Item 3.**Development Application: 184-200 Broadway, Chippendale - D/2024/1165****File Number: D/2024/1165****Summary****Date of Submission:** 17 December 2024**Applicant:** AVM PROJECT MANAGEMENT PTY LTD**Architect/Designer:** Durbach Block Jaggers Architects**Owner:** IDC PROPERTY NO 20 - BROADWAY PTY LTD**Planning Consultant:** The Planning Studio**Heritage Consultant:** Hericon Consulting**DAPRS:** 3 June 2025**Cost of Works:** \$13,053,015

Proposal Summary: Development approval is sought for the construction of a new six-storey backpackers accommodation consisting of 1,047 beds in 4, 5, 6, and 8 bed dormitory rooms.

Figure 22: Architectural plans highlighting subject dormitory rooms on level 1

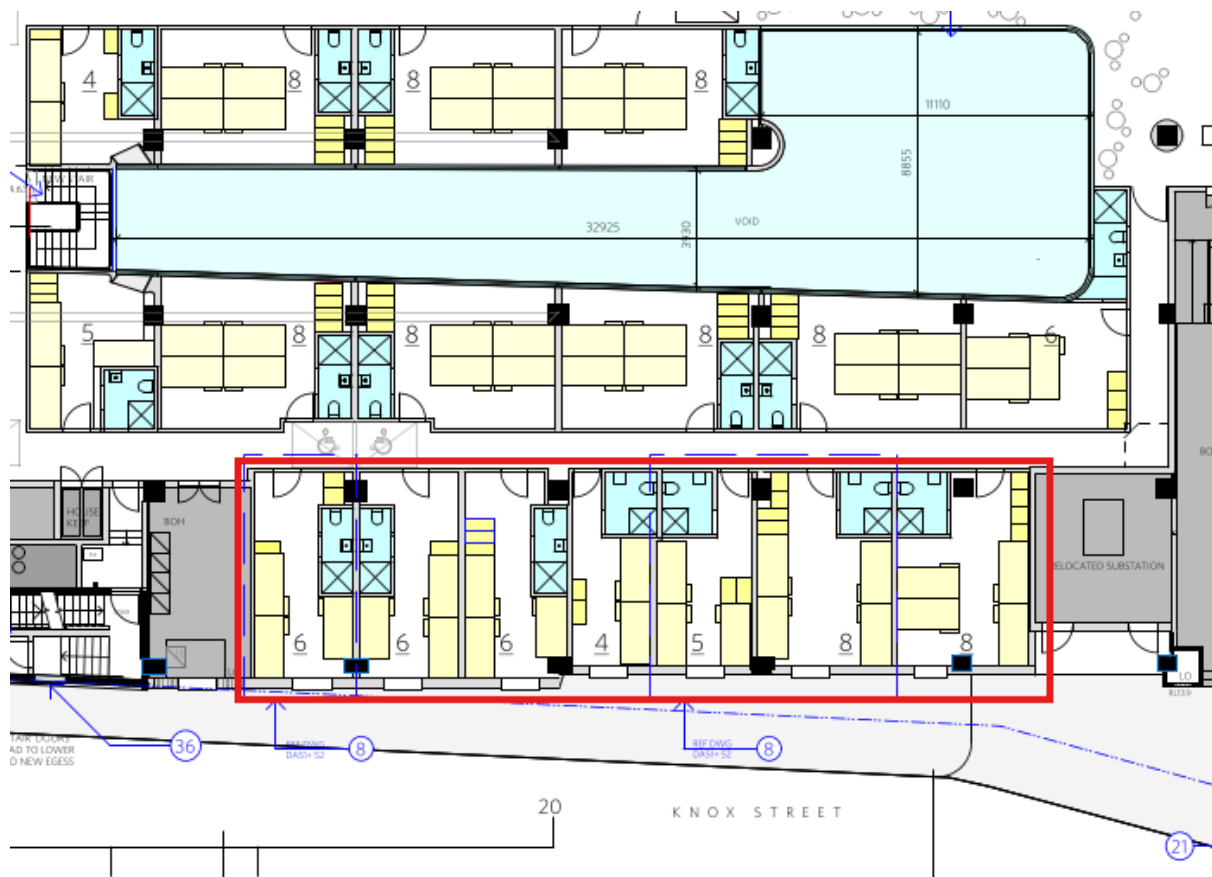
54. The proposed level 1 plan includes 7 dormitory rooms with a combined 43 beds fronting onto Knox Street. These rooms interface with the sloping street level of Knox Street and have windows directly onto the street as shown in Figures 22 and 23 below. Due to the direct interface between the street and the dormitory rooms, an appropriate balance between the amenity of the rooms, including natural light and outlook, and the privacy of the guest cannot be achieved.

55. As such, it is considered that these rooms are not appropriate to be used as dormitory rooms. As discussed in the DCP assessment above, there is insufficient internal common space, particularly for dining use, has been provided. Therefore, a condition of consent is recommended to delete the use of these rooms as dormitory accommodation, and to replace them with an internal common area (approximately 180sqm) which can be used for dining purposes.
